**Section 10**  
**HYDROLOGY, GEOLOGY AND HYDROGEOLOGY**

## Section 10: HYDROLOGY, GEOLOGY AND HYDROGEOLOGY

## **Additional Information – Revised Scoop Hill Community Wind Farm proposal:**

Title:  
**Figure 10.2.8: Peat Stability Risk Zones: Map 1 of 2**

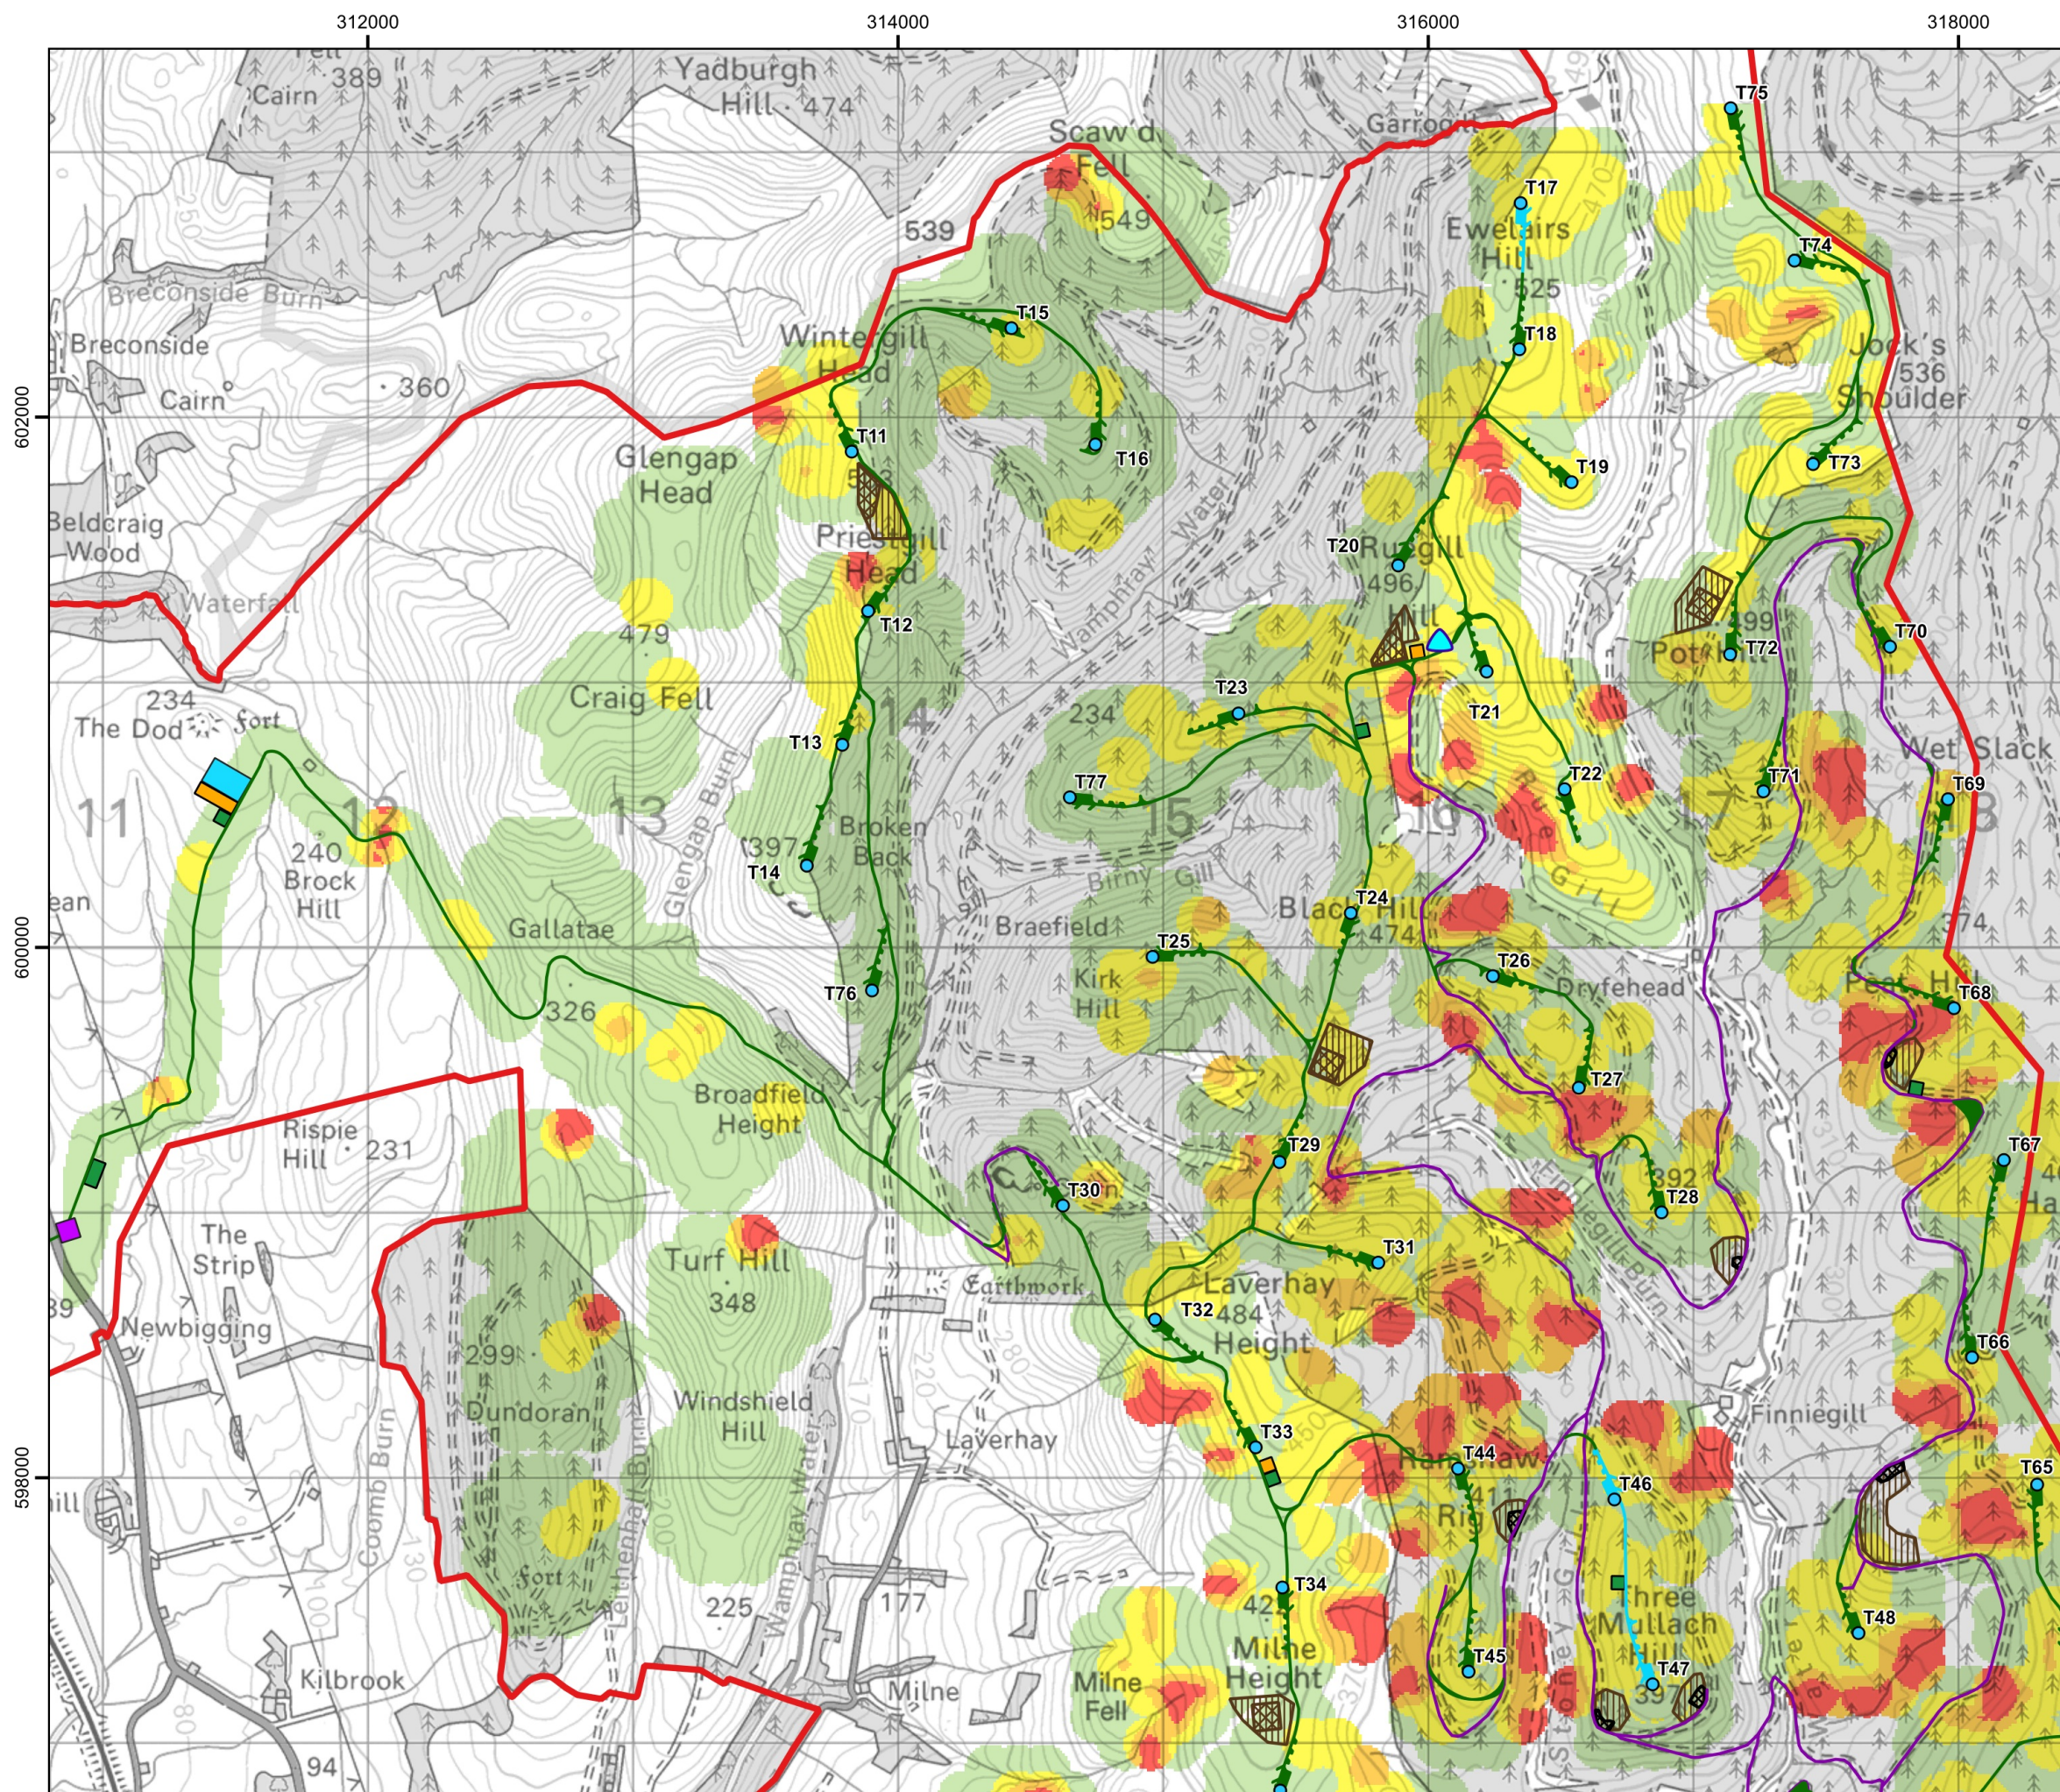
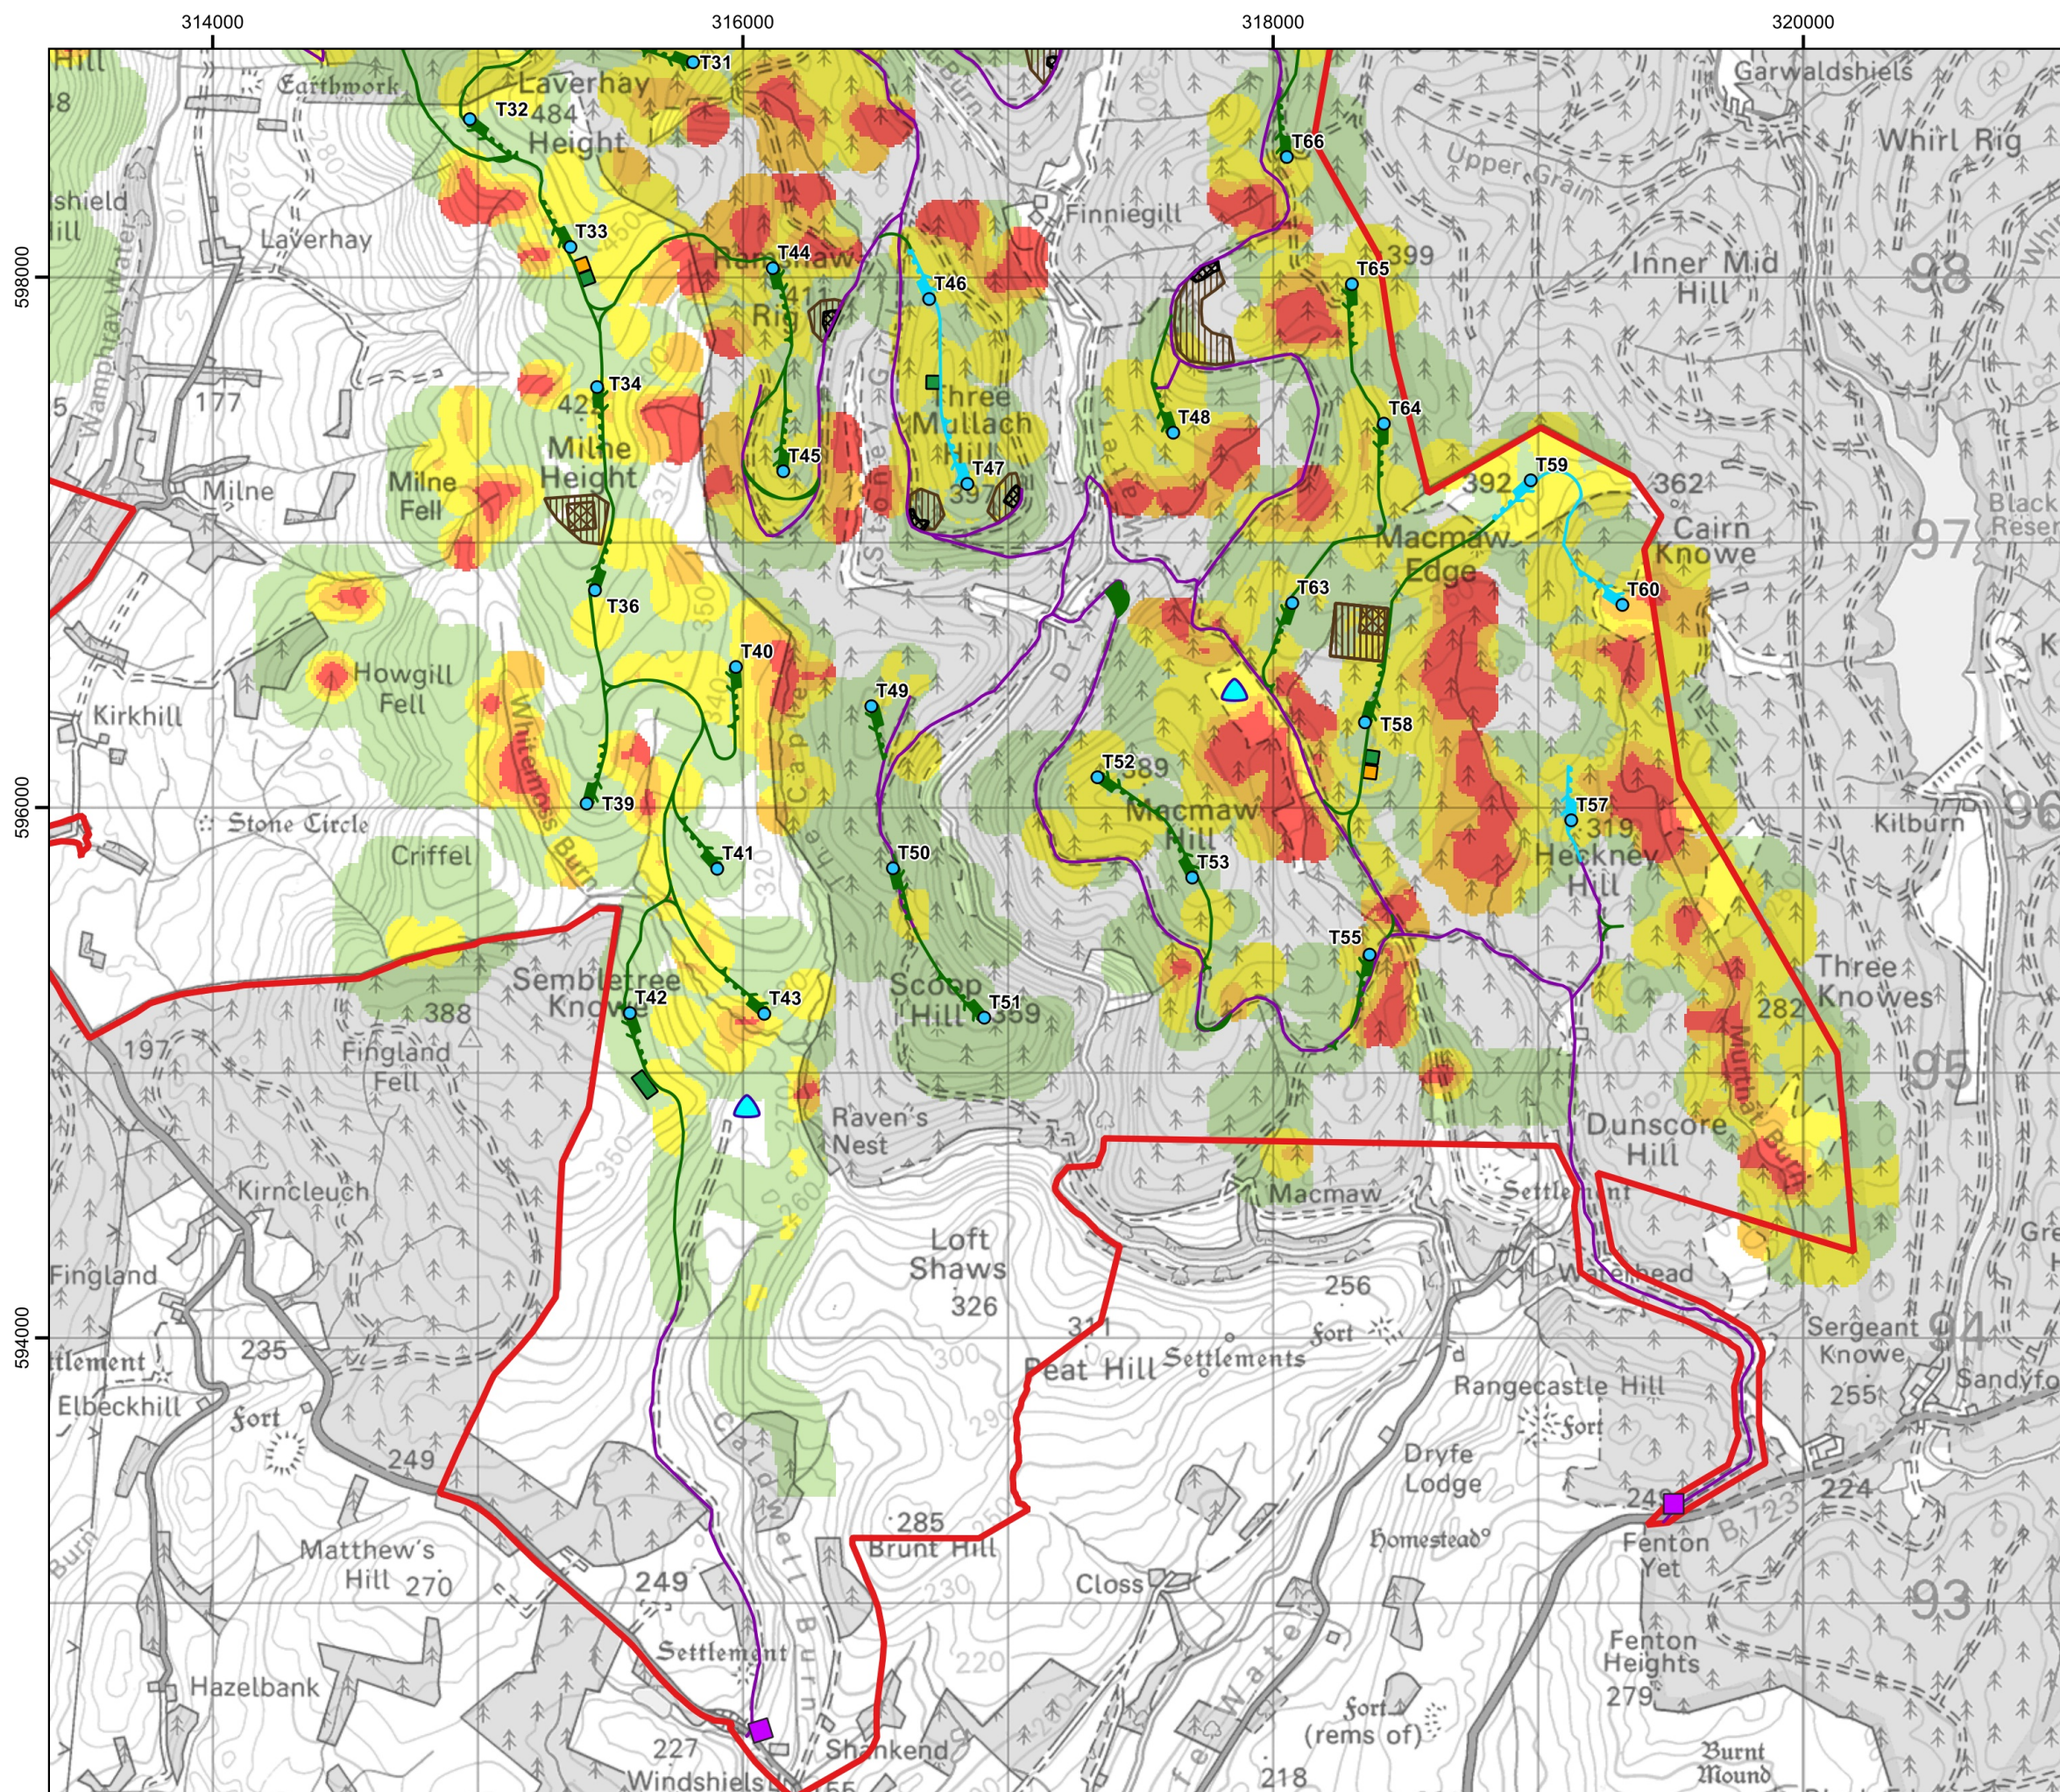
The Peat Stability Risk Zones mapping (Figure 10.2.8) only considers slope and peat depth vs receptor according to the notes beneath the key, so it appears other factors are not considered. Use of these factors alone appears reasonable as these are most critical. However, it still not clear why some areas chosen.

Reviewing Fig 10.2.8 – some of the tracks highlighted for assessment aren't covered by the Risk Zones mapping (eg north of T01, north east of T05, near Borrow Pit N5), whilst some areas of track seemly passing through medium/high risk areas according to this map aren't covered within Table 5.3 (e.g. main access route into site west of T08, track between T18 & T74). Unclear whether this is due to mitigation, explanation required.

As noted above Figure 10.2.8 contains the peat stability risk zone map which appears to be based on slope angle and peat depth – however limited detailed track probing has been carried out and the Phase 1 survey has significant gaps across large sections of access track and therefore it is not thought that these is sufficient coverage with ECUBPG notes in section 4.4.3.4 that:
